## Addendum 001

### Exterior Steel & Security Door Replacement Program

NC 20-1,2&3

Wilson Housing Authority

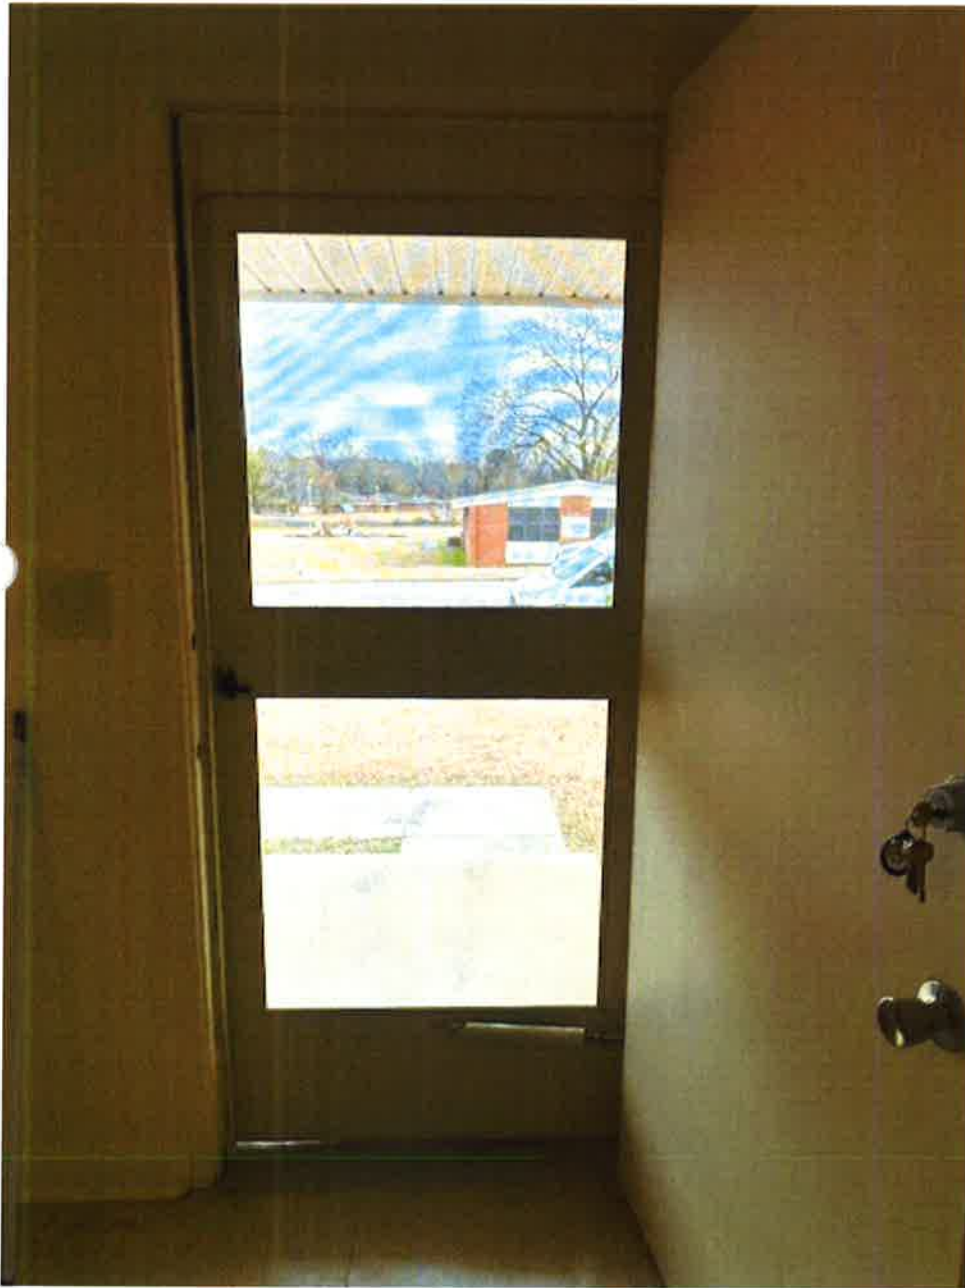
- Build down the 83” exterior door opening heights to accept 6’8” exterior steel doors. Please refer to the Bid/Summary Price Sheet; #7 on page 2 and pictures attached to this addendum.
- Security Screen Doors Manufacturer Change: TAPCO located in Tupelo, Mississippi. We are required to use American Made Products.
- If you have any questions regarding this Addendum 001, please email me @ [tdavis@wilsonha.org](mailto:tdavis@wilsonha.org).
- All questions will be shared with the bidders for transparency.

|   | Price |
|---|-------|
| 7. Build down the exterior door openings to accept 6'8" exterior steel doors. |       |
